VIRGINIA ELECTRIC AND POWER COMPANY
RICHMOND, VIRGINIA 23261

VIRGINIA ELECTRIC AND POWER COMPANY
SURRY POWER STATION (SPS) UNITS 1 AND 2
SUBSEQUENT LICENSE RENEWAL APPLICATION
RESPONSE TO REQUESTS FOR ADDITIONAL INFORMATION – SET 2

RESPONSE TO REQUESTS FOR ADDITIONAL INFORMATION
SET 2 REGARDING SPS SLRA

Figure 1 (Extracted from ETE-SLR-2018-1271)

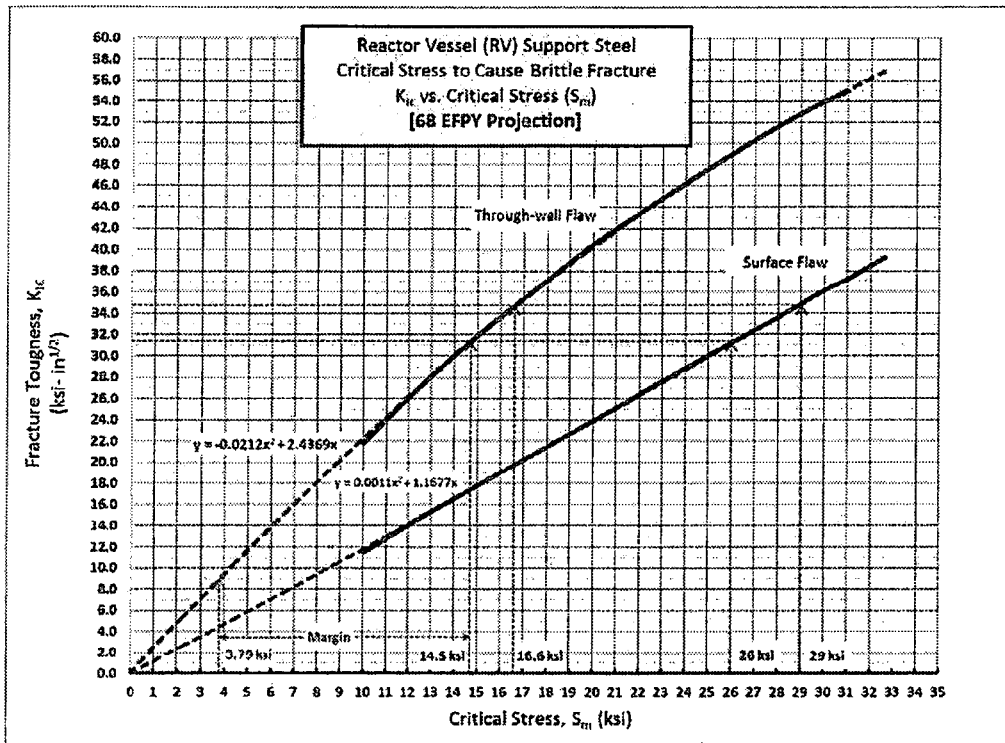
Due to lack of guidance for assessment of the embrittlement of the reactor vessel supports, it is recognized that utilization of the methods outlined in NUREG-1509, the 1986 Project Topical Report, and ETE-SLR-2018-1271 contains a level of uncertainty. The Dominion assessment outlined in the 1986 Project Topical Report and ETE-SLR-2018-1271 uses fracture mechanics formulas (consistent with those provided in ASME Boiler & Pressure Vessel Code, 2013 Edition, Section XI, "Rules for Inservice Inspection of Nuclear Power Plant Components," Appendix A) to demonstrate that a postulated surface flaw and postulated through wall flaw are stable based on a lower bound fracture toughness K_{IR} curve (i.e. $K_I < K_{IR}$), and does not propagate in an unstable behavior (i.e. brittle fracture). The assessment is performed by re-arranging the stress intensity factor formulas to back calculate the critical stress corresponding to when brittle fracture would occur. The results of the fracture mechanics evaluation from ETE-SLR-2018-1271 is shown in Figure 1.

Figure 2 Fracture Toughness K_{IR} and K_{Ic}

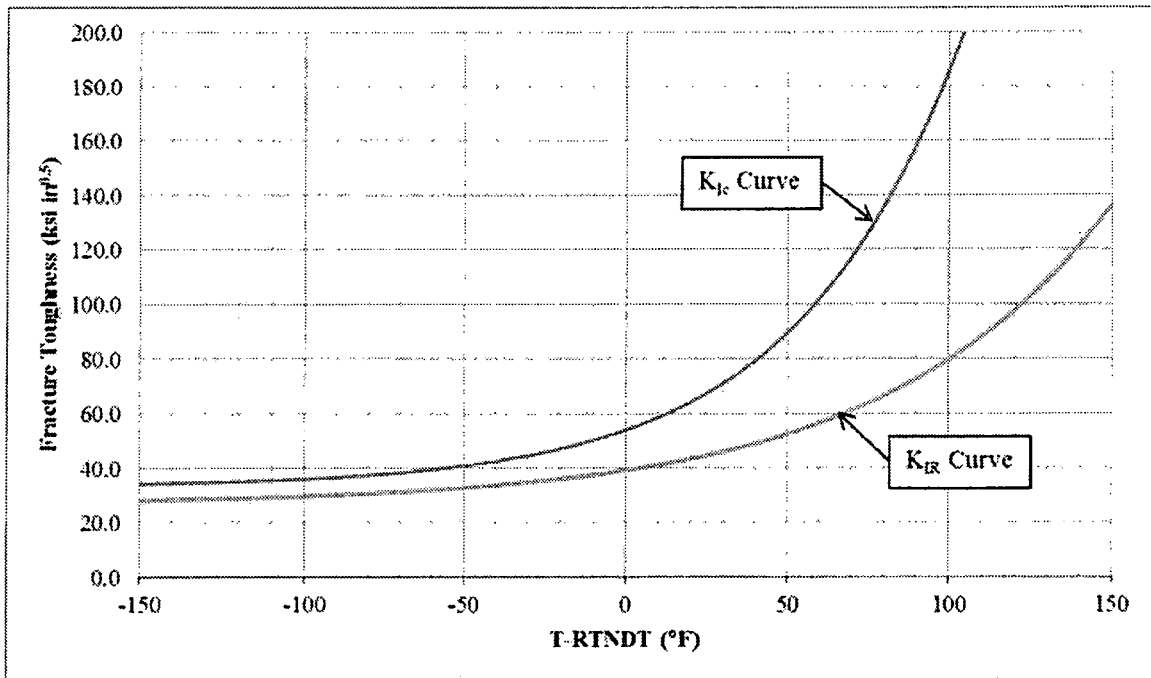
The sensitivity assessment shown below is based upon the lower bound K_{IR} value of $26.7 \text{ ksi}\sqrt{\text{in}}$ which accounts for an infinite amount of embrittlement shift in material properties. In other words, the value of $26.7 \text{ ksi}\sqrt{\text{in}}$ is the lowest value K_{IR} can reach when the value of $T-RT_{NDT}$ is very low (as shown in Figure 2), assuming a very high embrittlement and a large shift in RT_{NDT} based on NUREG-1509, Figure 3-1.

Figure 3 Sensitivity Assessment ($K_{IR}/\sqrt{2}$)

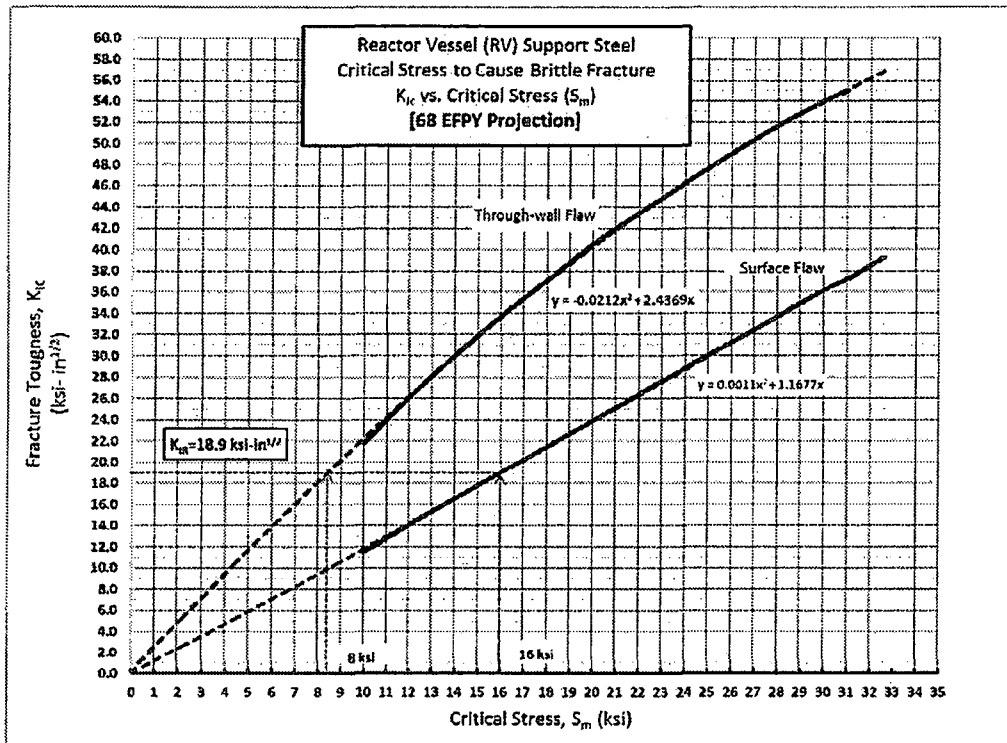
Incorporating a safety margin based on IWB-3600, gives $K_{IR}/\sqrt{2} = 18.9 \text{ ksi}\sqrt{\text{in}}$. Based on Figure 3 below, for $K_{IR}/\sqrt{2} = 18.9 \text{ ksi}\sqrt{\text{in}}$, the postulated through-wall flaw has a S_m that is approximately 8 ksi, while for the surface flaw, the S_m is approximately 16 ksi. These above mentioned S_m values are larger than the applied tensile stresses from Table 1 (6.31 ksi) and from Table 2 (6.28 ksi) of ETE-SLR-2018-1271 for both the postulated through-wall flaw and the postulated 1/4T surface flaw, respectively.

Per Figure 3, based upon the lower bound K_{IR} value of 18.9 ksi $\sqrt{\text{in}}$, which includes the safety margin of $\sqrt{2}$, the calculated critical (allowable) stresses for a through-wall flow and surface flow are approximately 8 ksi and 16 ksi, respectively. These S_m values are larger than the applied tensile stresses from Table 1 (6.31 ksi) and from Table 2

Thus, the RV supports are acceptable even if a lower bound K_{IR} of 26.7 ksi $\sqrt{\text{in}}$ is considered with incorporation of safety margins from IWB-3600. Therefore, the neutron shield tank will maintain structural integrity throughout its lifetime (even past 80 years of operation, if the design basis stress stays below the critical stresses) since it is not possible to experience neutron damage in excess of that illustrated by the lower bound K_{IR} value.

Figure 1: 2019 Edition ASME Section XI Figure C-4210-1

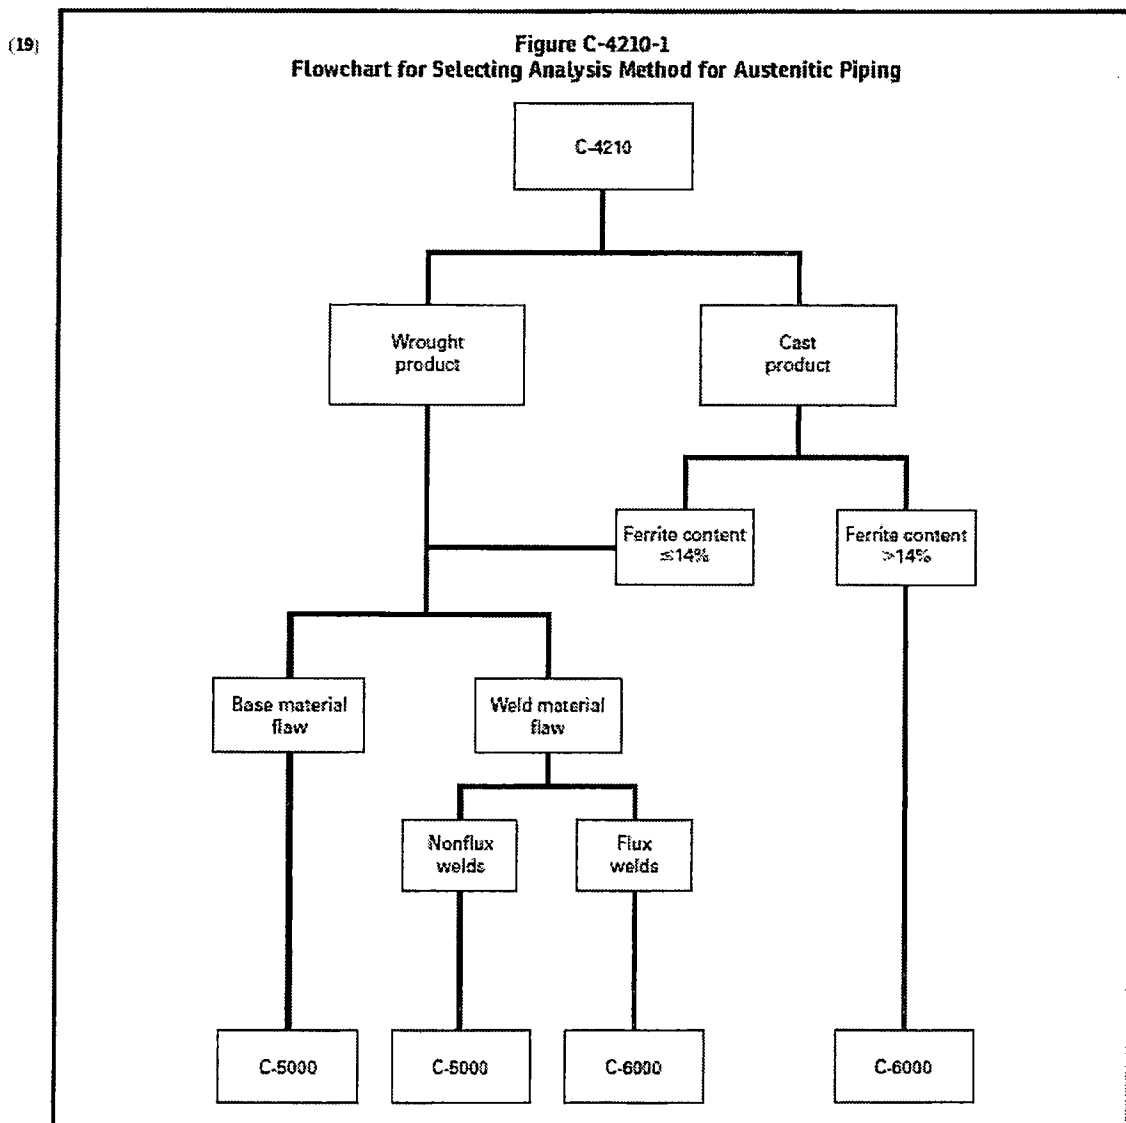
There are no flaw evaluation guidelines for CASS piping with delta ferrite content equal to or greater than 20% (as shown in Figure C-4210-1 of Appendix C) up to the current 2017 Edition of ASME Code, Section XI Appendix C. Over the last three years, the ASME Code Working Group on Pipe Flaw Evaluation had been developing a basis to update Appendix C and Figure C-4210-1 to provide guidance for CASS materials with different levels of delta ferrite content. The 2019 Edition of the ASME Code, which is scheduled to be published in July 2019, has updated Appendix C and Figure C-4210-1 (see Figure 1 herein) for use of limit load with SAW Z-factors for delta ferrite levels greater than 14% but less than or equal to 25%. For ferrite levels below 14%, limit load is sufficient with no use of Z-factors, while for ferrite levels greater than 25%, the flaw

] ^{a,c,e} the flaw evaluation per limit load methodology with Z-factors based on SAW per ASME Code, Section XI Appendix C is acceptable as the latest 2019 Edition has updated Figure C-4210-1 and the guidance for CASS piping with delta ferrite greater than 20%.

Figure 2: PVP2017-66100, Figures 10 and 11

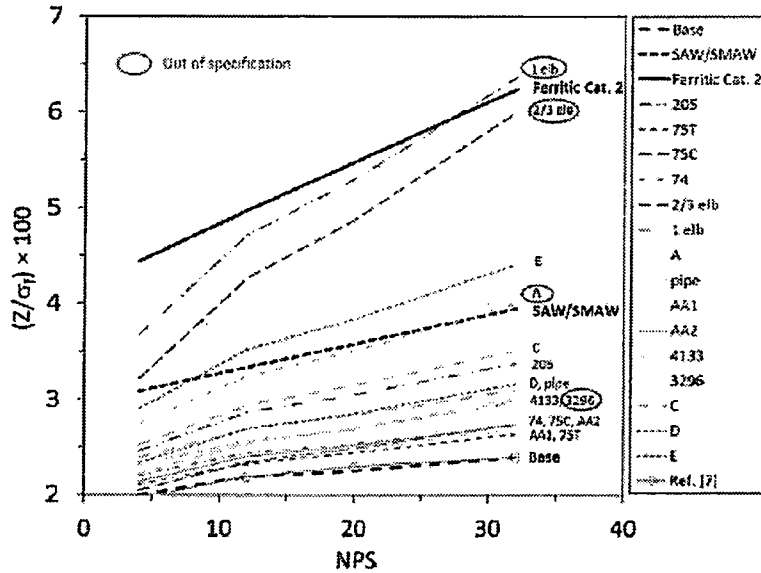
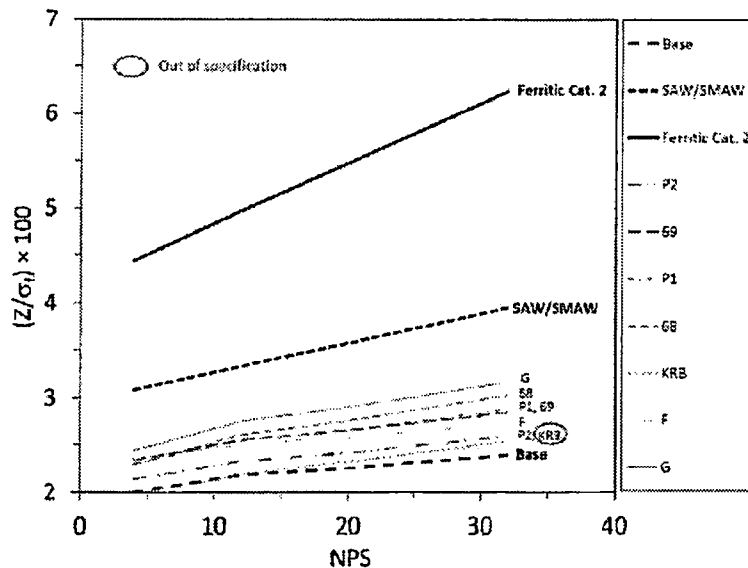
Based on PVP2017-66100, which forms the technical basis for the 2019 Edition of ASME Section XI Appendix C changes, two data plots can be used to summarize the background of the methodology updates. Figures 10 and 11 from PVP2017-66100 (shown in Figure 2 herein) compares the normalized Z-factor to flow strength as a function of nominal pipe sizes for Grade CF8M and CF3/CF8 CASS materials. For the development of the technical basis in PVP2017-66100, normalized Z-factor is used because the experimental data had varying degrees of flow stress; therefore, a more accurate comparison of the normalized Z-factor is employed in the PVP paper. Also shown in Figures 10 and 11 of PVP2017-66100 are the Z-factors for wrought stainless steel (base metal), Submerged Arc Weld (SAW) / Shielded Metal Arc Weld (SMAW) and the ferritic steel Category 2 piping material in ASME Code, Section XI.

Based on Figure 10 of PVP2017-66100 for Grade CF8M, it is demonstrated that the normalized Z-factor for the two data points which falls between 0 and 14% ferrite content (Heat IDs AA1 and AA2, see PVP2017-66100) are very close to the wrought stainless steel, thereby confirming that Grade CF8M CASS in this delta ferrite content range can be treated as wrought stainless steel. The seven data points between 14% and 25% (Heat IDs D, Pipe, 74, 75C, 75T, 205 and 4133) all have normalized Z-factors that are less than the corresponding normalized Z-factors for the SAW/SMAW material, thereby justifying the conservative use of the Z-factor for the SAW/SMAW material for Grade CF8M CASS piping with delta ferrite content in the 14% to 25% range. It can also be seen that the remaining six data points (Heat IDs A, C, E, 1ELB, 2/3ELB and 3296) with delta ferrite contents greater than 25% have normalized Z-factors that are below

For Grades CF3/CF8, it can be seen from Figure 11 of PVP2017-66100 that normalized Z-factors for the two data points with ferrite content less than 14% (Heat P2 and F) are very close to that of the wrought base metal which indicates that delta ferrite content in this range can also be treated as the wrought base metal. All other heats with delta ferrite content greater than 14% have normalized Z-factors which are fairly above that for the wrought base metal but less than that for the SAW/SMAW and, as such, it is conservative to use the criteria for the SAW/SMAW presently in the ASME Code for these CASS Grades for delta ferrite content greater than 14%.

Figure 2: Figure 6-6 from WCAP-18258

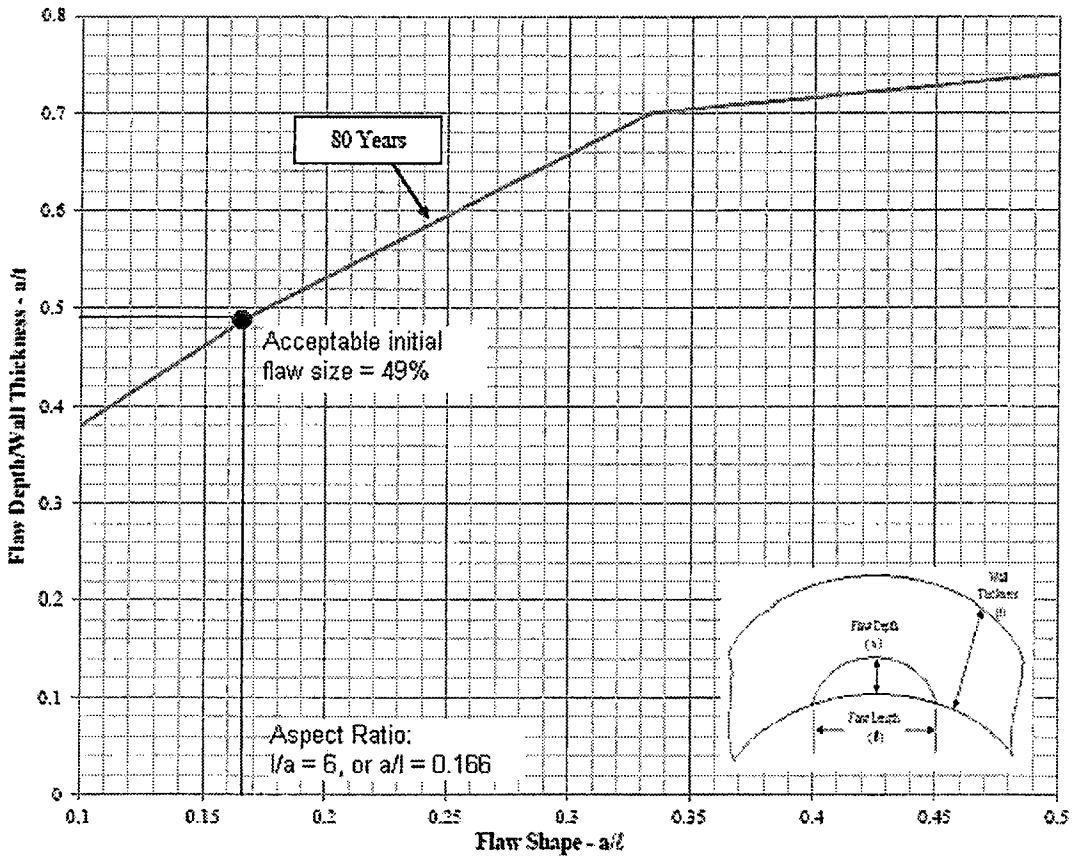
Discuss assessment of the cold leg circumferential flaw information in Table 6-1 and Figure 6-6 of WCAP-18258.

Using Figure 6-6 (see Figure 2 below) as an example for explanation purposes; the chart is for postulated circumferential flaws in the cold leg. Table 6-1 (see Figure 1 below) shows supplemental information for explanation since it contains numerical values. The information in Table 6-1 is for an aspect ratio of $l/a = 6$ (or $a/l = 0.1666$), an aspect ratio of 6 is picked because it is a common flaw case used throughout the industry for fracture mechanics assessment and evaluation.

Figure 6-6, includes a single blue curve labeled as 80 years. This curve was constructed by first determining the maximum allowable end of evaluation flaw size. The maximum end-of-evaluation flaw size is not shown on the curve in Figure 6-6. However, in Table 6-1, the maximum end-of-evaluation flaw size for AR (aspect ratio) = 6 is 50% (a/t) of the wall thickness. The maximum allowable end of evaluation flaw size of 50% is based on limit load analysis per ASME Section XI App C. This flaw size is calculated based on plastic collapse and is also frequently called the critical flaw size. The circumferential maximum allowable end of evaluation flaw sizes is based upon dead weight, pressure, thermal expansion, seismic, and LOCA loads (see Table 2-2 of WCAP-18258). The maximum allowable end of evaluation flaw size is the largest final flaw size for which the pipe can theoretically fail based on ASME Section XI guidance.

The blue curve of Figure 6-6, plotted for $a/l = 0.166$ (AR = 6:1), shows the acceptable initial flaw size = 49%. This value of 49% of the wall thickness is also presented in Table 6-1 as the acceptable initial flaw size. Therefore, this case demonstrates that the cold leg piping can tolerate a flaw size of 49% of the wall thickness for 80 years for AR = 6. Any flaws with AR = 6 that are less than 49% of the wall thickness are acceptable for 80 years. Similar to AR = 6, the blue curve is composed of other aspect ratios ranging from 2 to 10, and the calculated acceptable initial flaw sizes are graphically illustrated on Figure 6-6. Any flaw sizes that fall below the blue curve on Figure 6-6 are acceptable for 80 years based on ASME Section XI, and any flaws above the blue curve are unacceptable. As a concluding remark in Table 6-1, the difference between the acceptable initial flaw size and the maximum allowable end of evaluation flaw sizes is the amount of crack growth in 80 years. For the case of AR = 6 for the cold leg circumferential flaw, the growth is only 1%.
